200802-M (Replaces 200232-M)

## Wisconsin Building Products Evaluation

Engineered Metal Building System

American Building Company  
1150 State Docks Road  
Eufaula, AL 36027

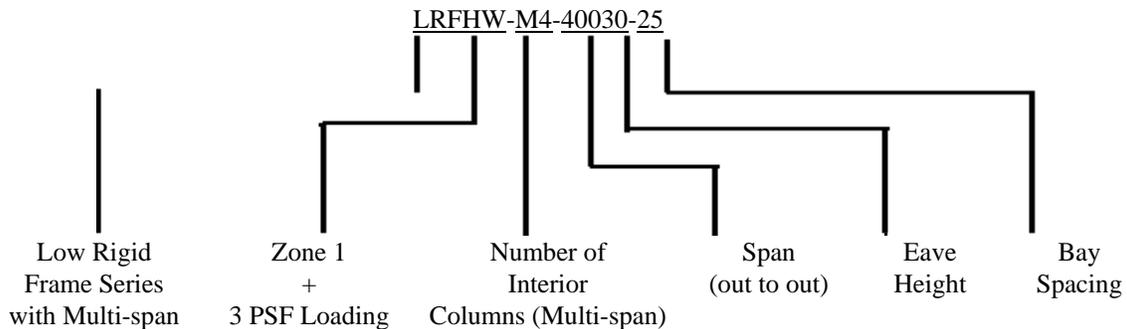
The load combination, DL + ½ LL + LL, without the wind load, requires the ridge rafters to be changed to the next flange thickness for the 120' and 80' span frames. The 30' span does not require any change.
